PEACH BOTTOM ATOMIC POWER STATION, UNIT NO. 2

AMENDMENT TO FACILITY OPERATING LICENSE

Amendment No. 70
License No. DPR-44

ATTACHMENT TO LICENSE AMENDMENT NO. 70

Figure 3.5.1.C Maximum Average Planar Linear Heat Generation Rate Versus Planar Average Exposure

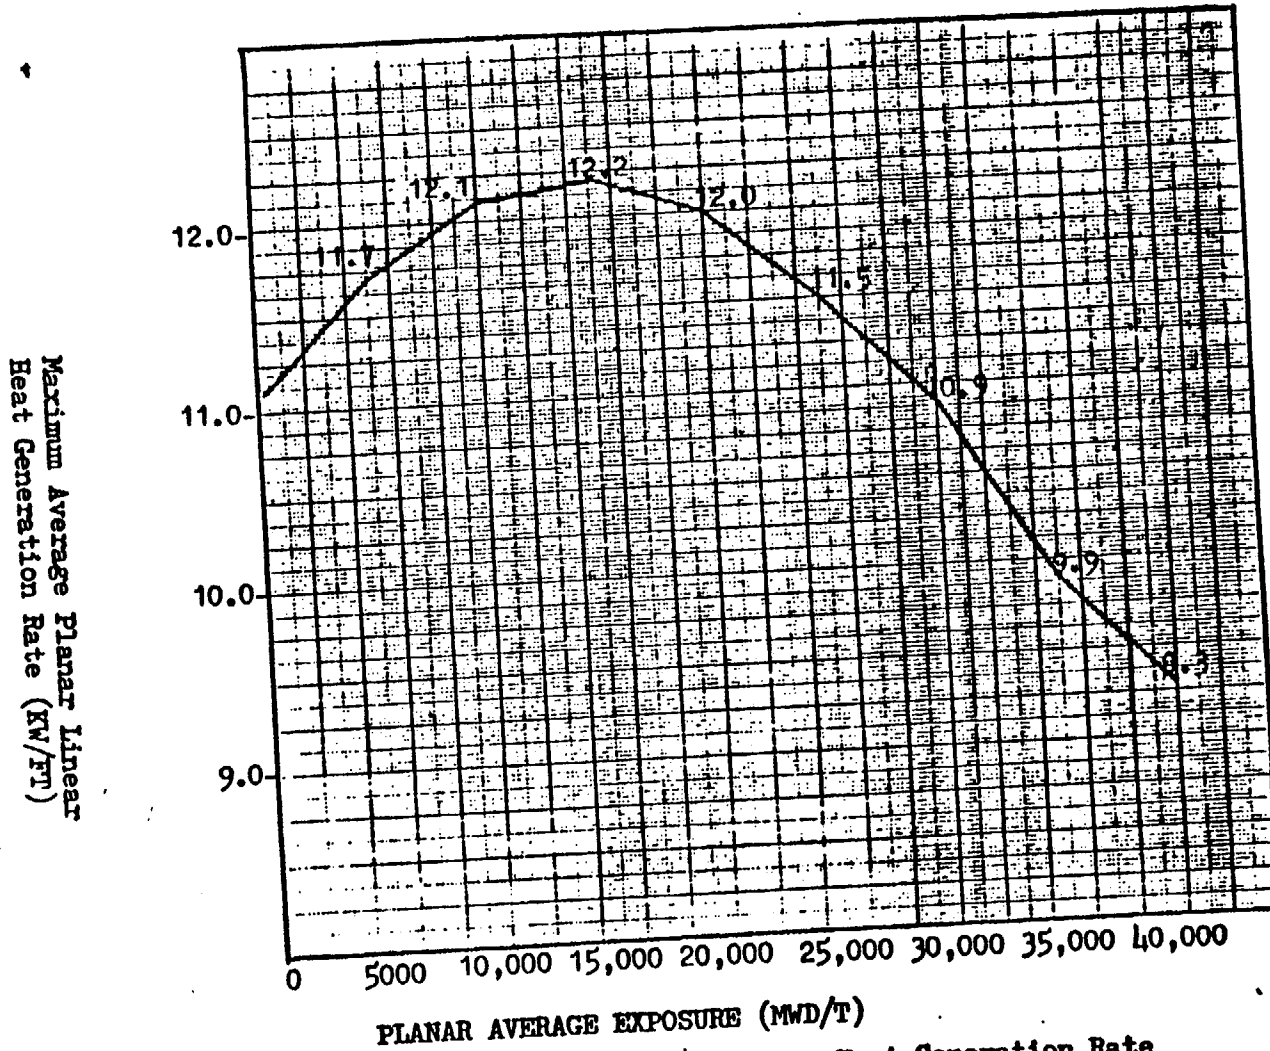
The calculational procedure used to establish the APLHGR shown on Figures 3.5.1.C, D, F, G, H, and I is based on a loss-of-coolant accident analysis. The analysis was performed using General Electric (GE) calculational models which are consistent with the requirements of Appendix K to 10 CFR Part 50. A complete discussion of each code employed in the analysis is presented in Reference 4. Input and model changes in the Peach Bottom loss-of-coolant analysis which are different from the previous analyses performed with Reference 4 are described in detail in Reference 8. These changes to the analysis include: (1) consideration of the counter current flow limiting (CCFL) effect, (2) corrected code inputs, and (3) the effect of drilling alternate flow paths in the bundle lower tie plate.
